Date of publication: April 22nd, 2019

Product: Helios4

Helios4 design was modified to provide better isolation between Fan control signals and the ARMADA 388 SoC GPIO pins. The change is motivated by few reports of product damage to the said SoC GPIO pins during wrong manipulation.

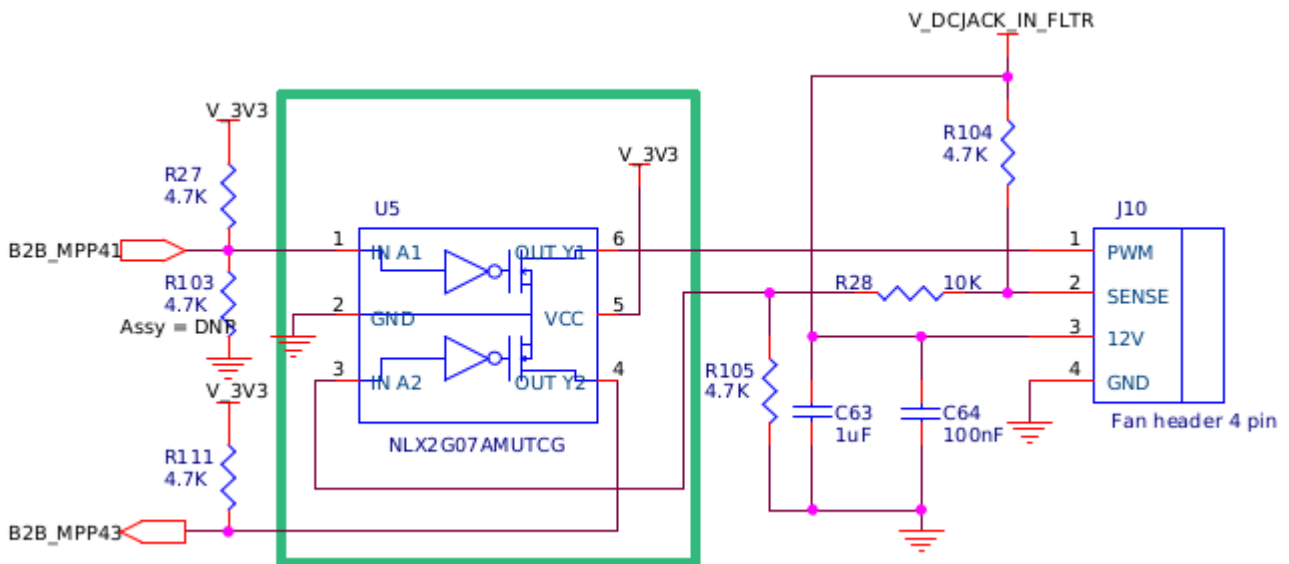
To be in line with 4-wire PWM Fan specifications which requires the PWM pin to be open-drain and 5V tolerant, a non-inverting buffer has been added for each GPIO PWM pin as shown in the schematic above.
